Subject: Reference: Submission of revised septic design plans Lee Robinson, lots 3 and 4, Upton Street

On-Site Sewage Disposal System

Located At Lot 3

179 Upton Street Assessors Parcel 86-0-11B

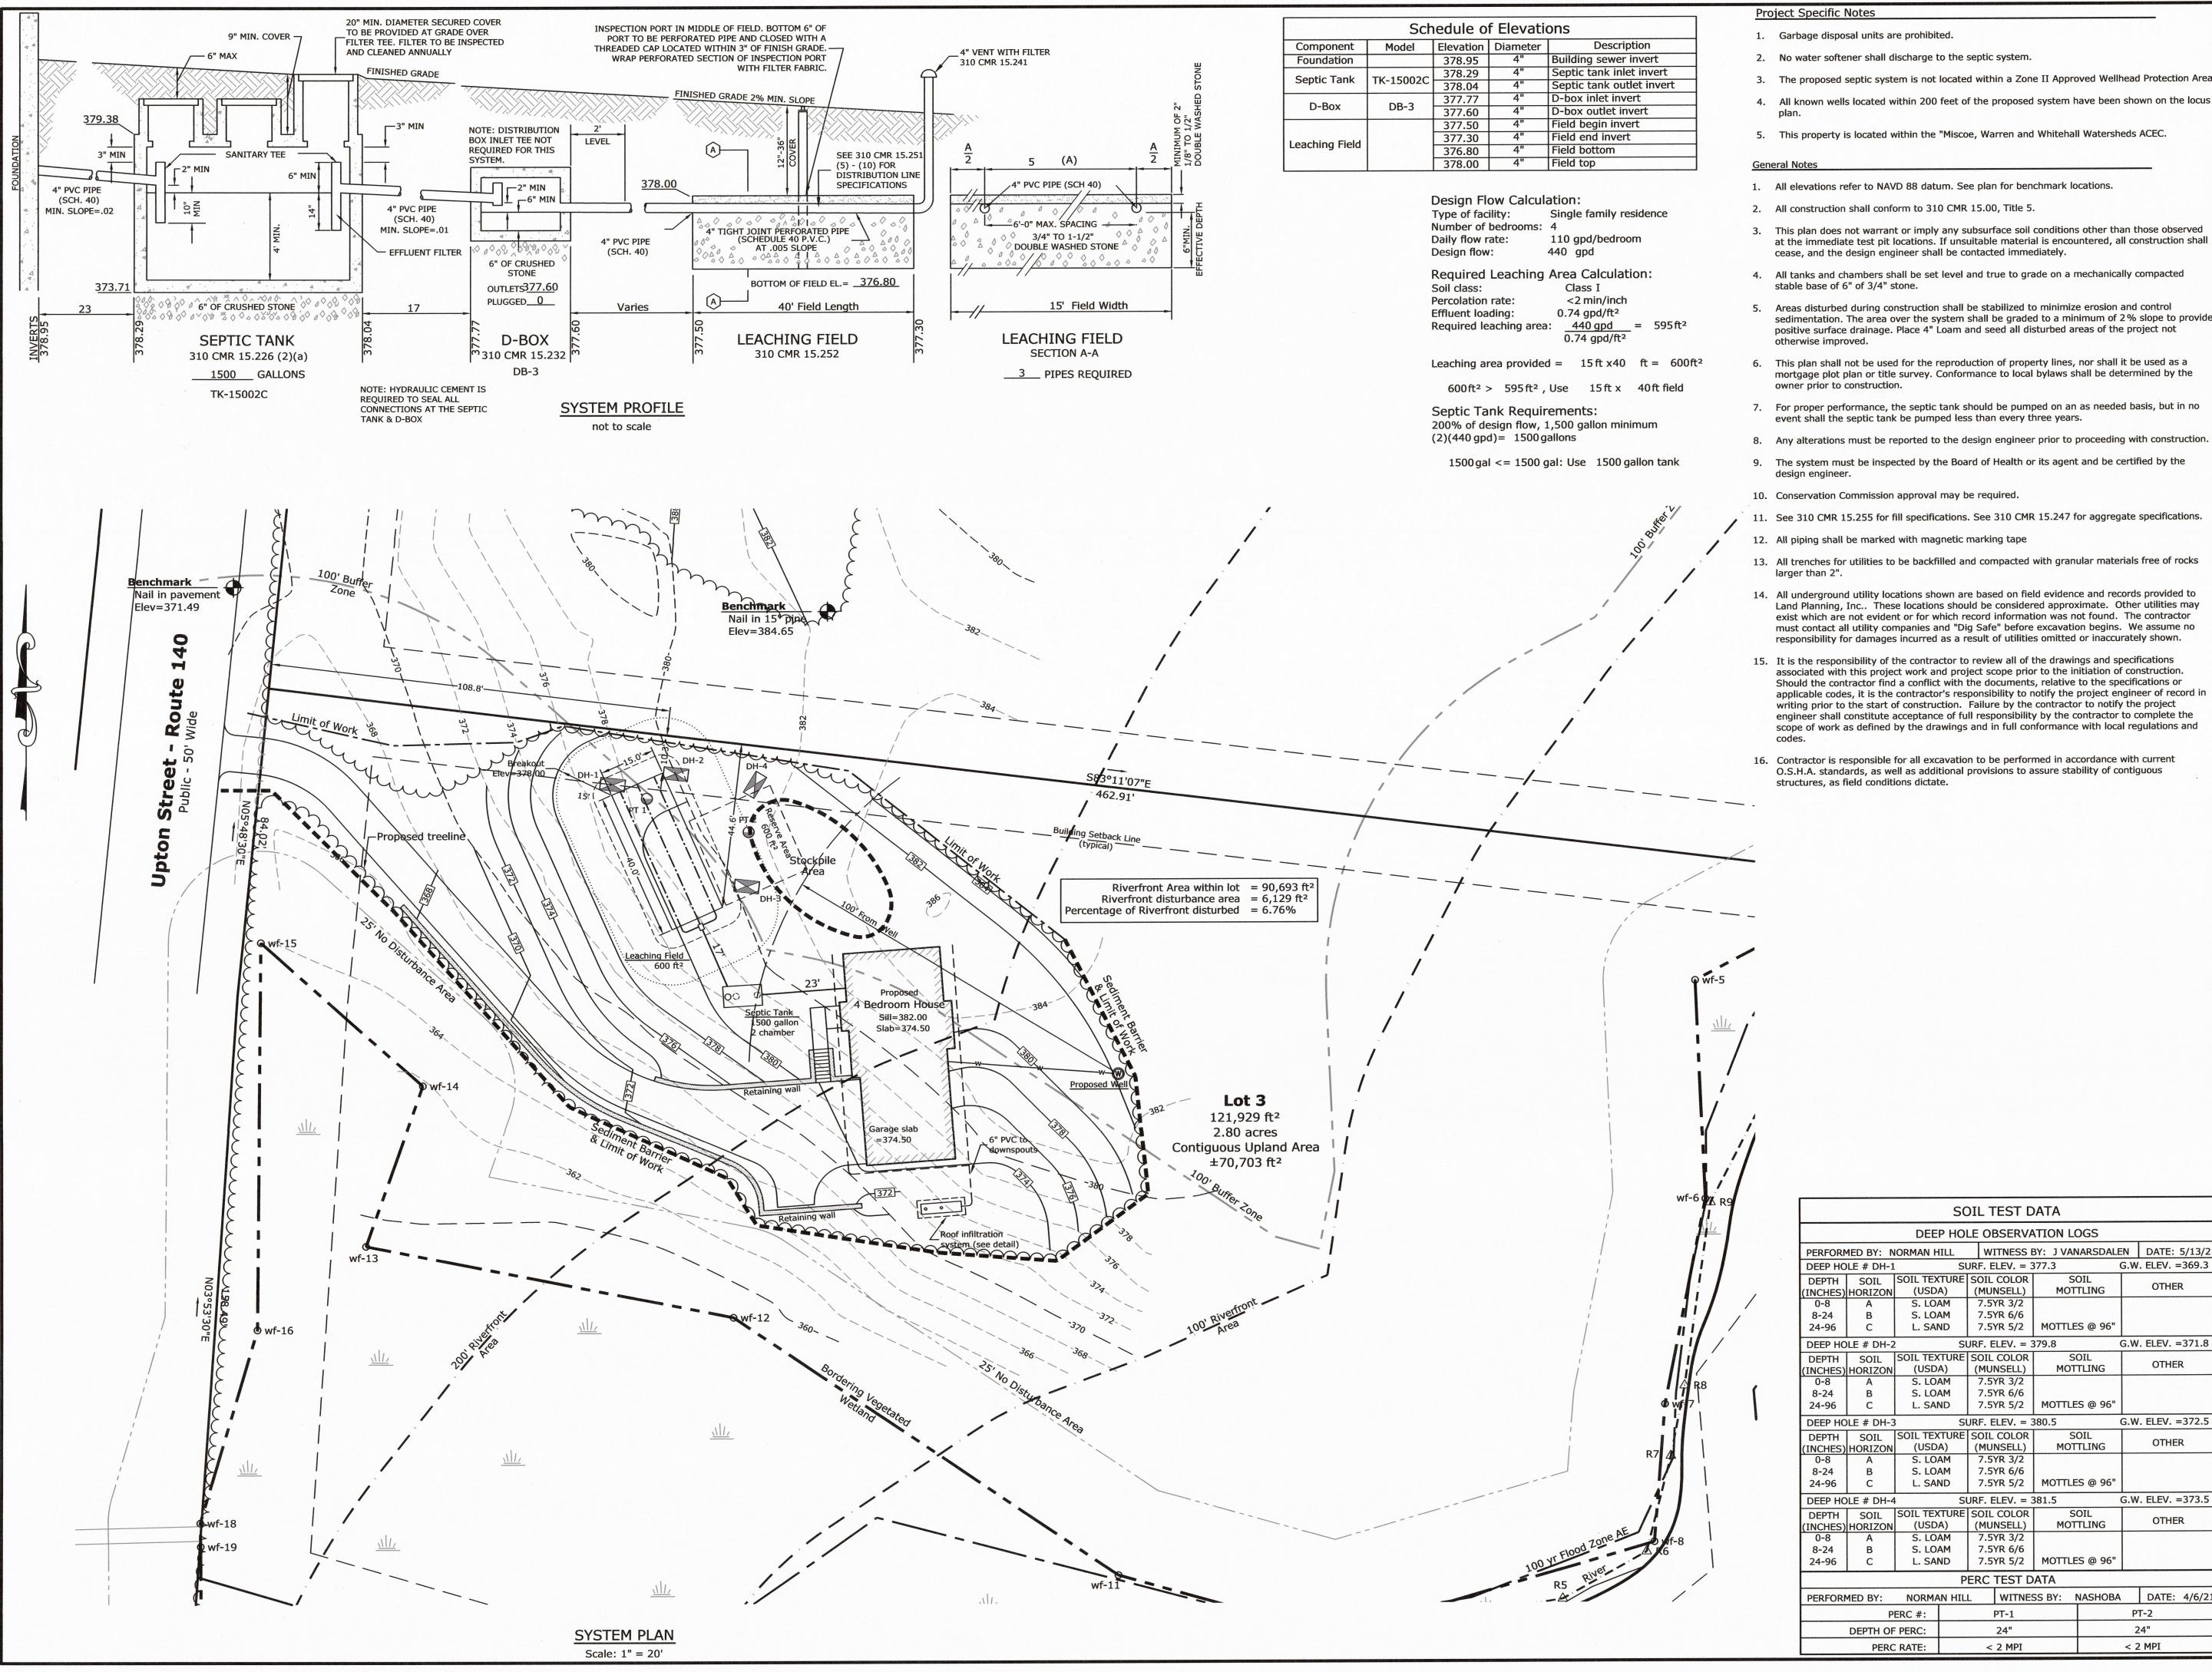
- On lots 3 and 4, we moved the stockpile area out of the buffer zone, and we added the upland area for both lots.
- On Lot 3 we moved the proposed siltation controls out of the 25 foot no disturb zone.
